STRUCTURAL ENGINEERING REPORT

Structural Condition Audit

**Sutton Beach Pavilion 1
Marine Parade, Redcliffe QLD 4020**

FS1499FL-SER01

1 PAVILION 1 - GROUND FLOOR (EXISTING)
SCALE: 1 : 150

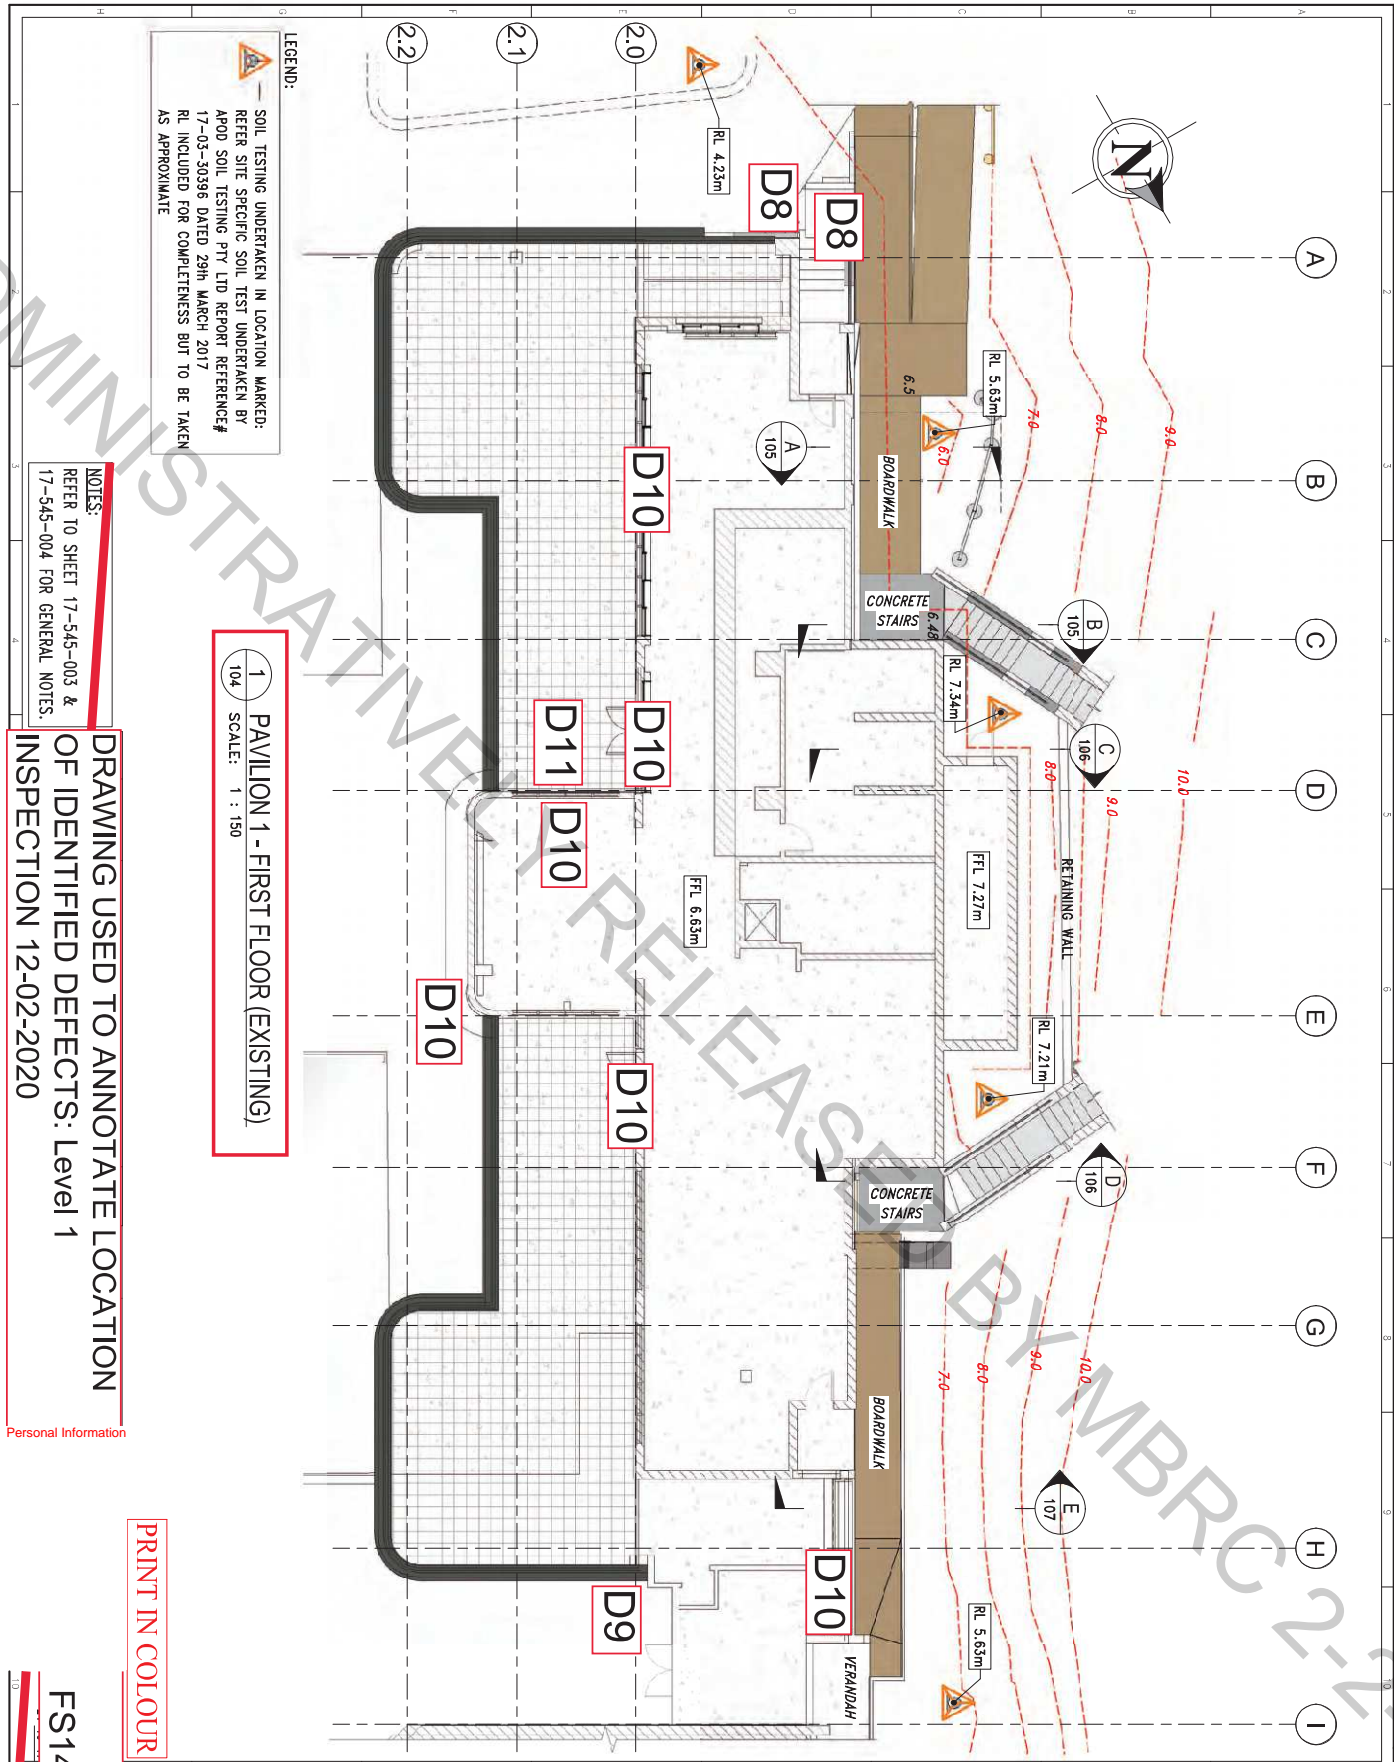
EXISTING BUILDING REAR WALL
SUBJECT TO WATER INGRESS

DRAWING USED TO ANNOTATE LOCATION
OF IDENTIFIED DEFECTS: Ground Level
INSPECTION 12-02-2020

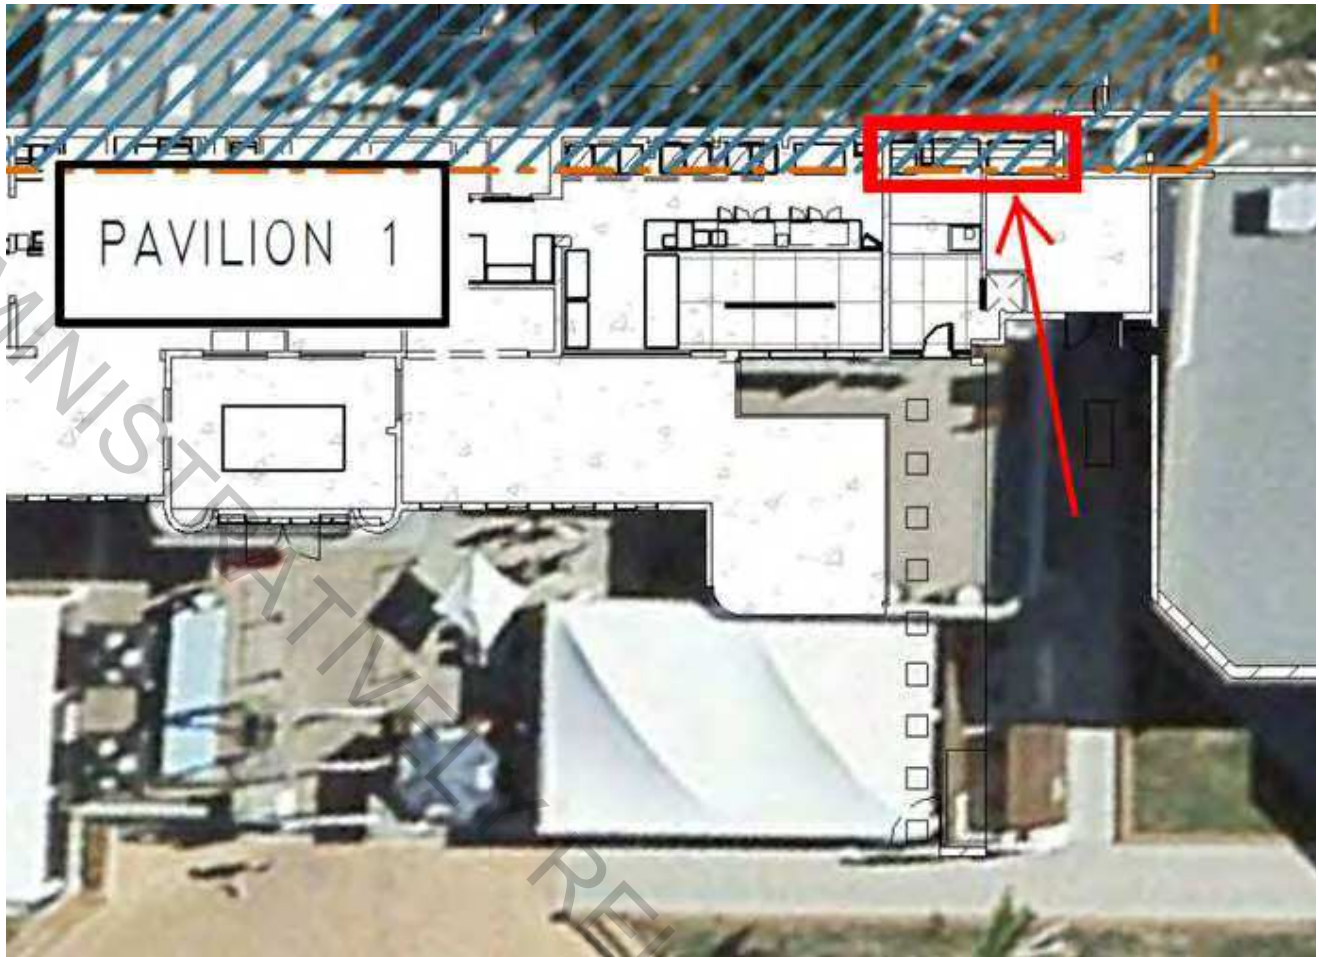
- i. Both [REDACTED] and myself saw this as a significant electrical safety hazard that requires immediate rectification
5. No attempt at waterproofing the recent block wall was made hence any water that enters this area will relatively easily migrate through the wall

6. Local support of a bearer has been compromised (although the joist appears to be robust enough and is not spliced through the remaining span that it is not at imminent risk of collapse

[REDACTED], item 4a needs immediate attention in our opinion to mitigate a potential electrical hazard / risk. Temporary propping of the cable tray would be a good immediate risk mitigation method, the cabling should be assessed for fitness for purpose.
